ATTACHMENT 1

Response to NRC Questions

10CFR71 QA PROGRAM

Figure 3

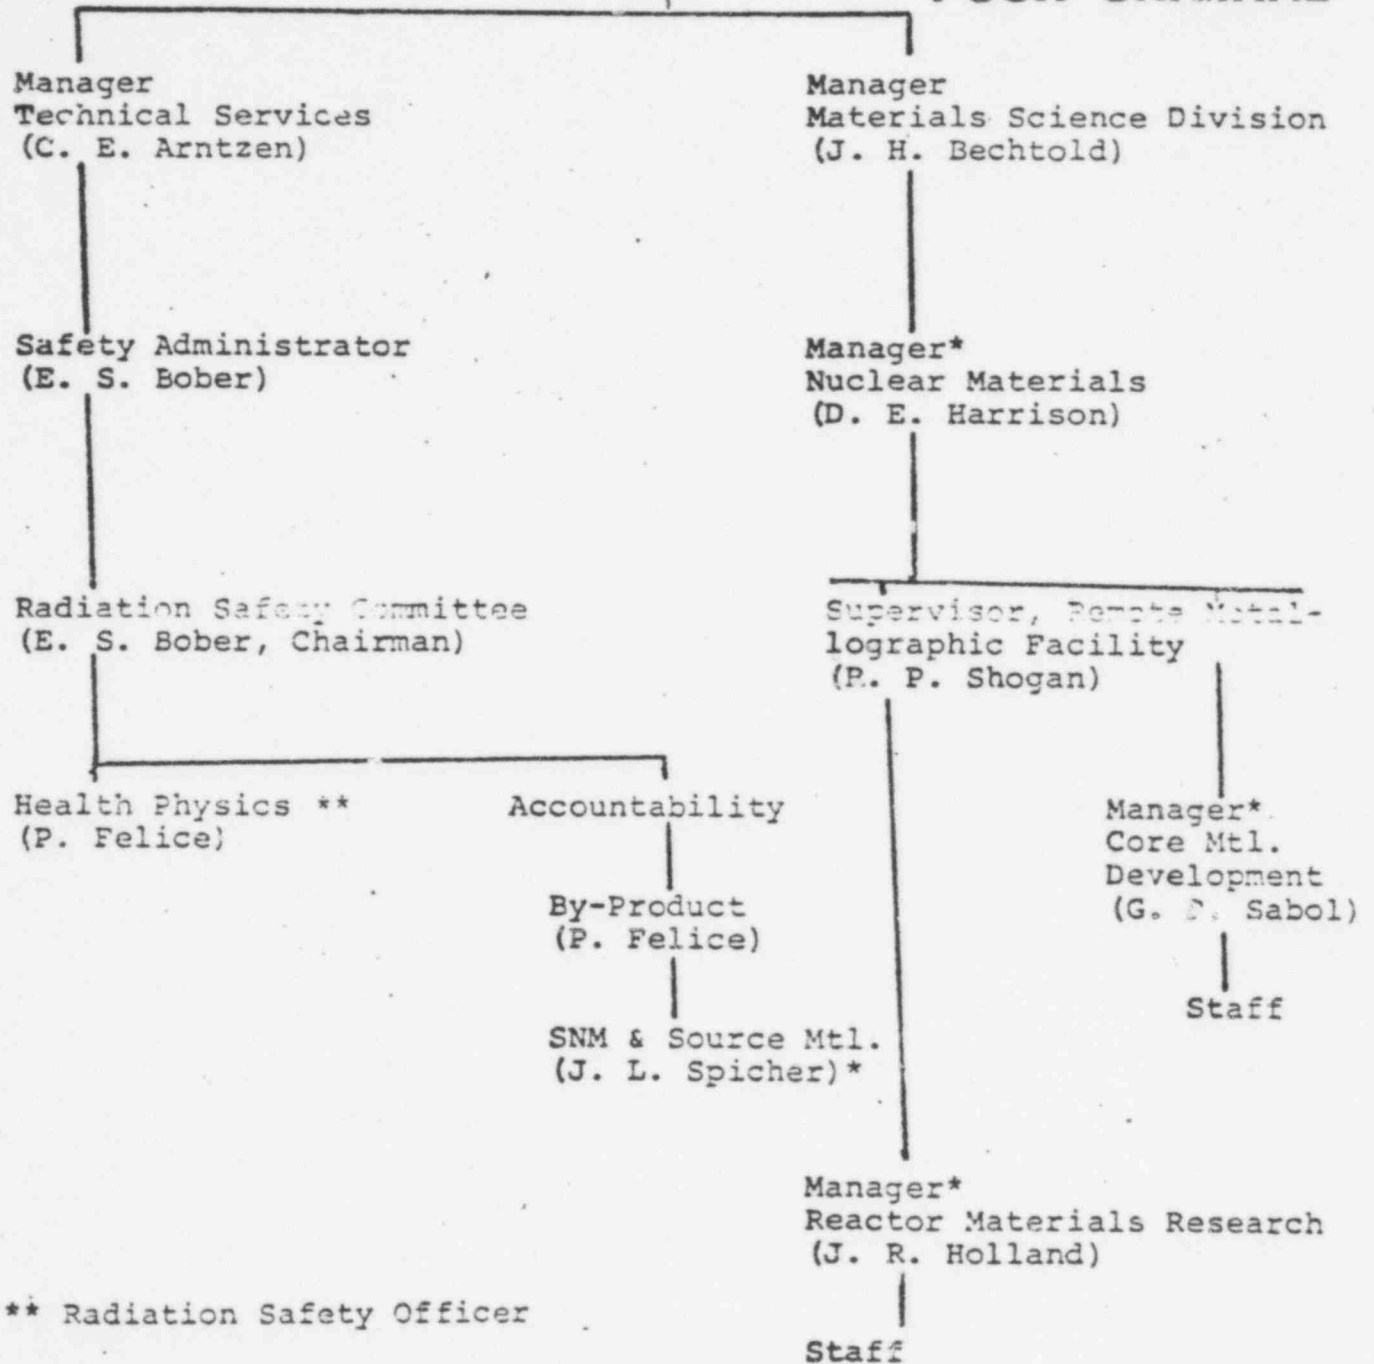
3. Parts 6 and 7 show the radiation safety officer having specific responsibilities. Identify the Radiation Safety Officer (by title) on Figures 2 and 3.

Response. Figures 2 and 3 have been revised to identify the Radiation Safety Officer.
